JABIRU AIRCRAFT PTY LTD

Engineering Report: AVDALSR087-2

Subject: Procedure For Upgrading 12 Pole Alternator

Figure 9 - Wiring Schematics

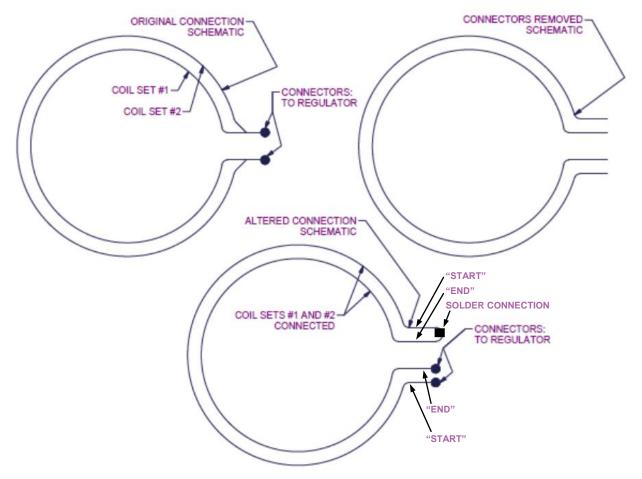
At manufacture, the 12 pole stator assembly was wound with 2 circuits in parallel. This reduces the effective length of the windings, limiting the output at low engine RPM. By re-connecting the wound coils on the stator in series, the effective length of the windings are increased, with a corresponding increase to the output voltage. The procedure given below details how the change may be carried out to engines in service.

- 1. A schematic showing the current and altered wiring is shown in Figure 9.
- 2. Disconnect the battery before you commence any work.
- 3. Disconnect stator wiring terminals and harness wire ties, then remove retaining bolts holding the rear plate and stator assembly from the engine, as shown in Figure 1.

9. Twist any "Start" wire to any "End" wire. Solder and insulate with heat shrink. Fold down between the coils. Take care that the connection is appropriately insulated, restrained and positioned: over time parts rubbing are likely to eventually damage the insulating lacquer on the wires and produce a short. Note that loads and vibrations applied to the alternator assembly from the magnets of the rotor are of relatively high magnitude and parts must be treated appropriately.

10. Insert the other 2 wires (1 "Start" and 1 "End"), one into each lead terminal and re-solder. Slide the white and black insulation back down over the soldered terminals and fold down between the coils over the previously joined pair of wires, as shown in Figure 8.
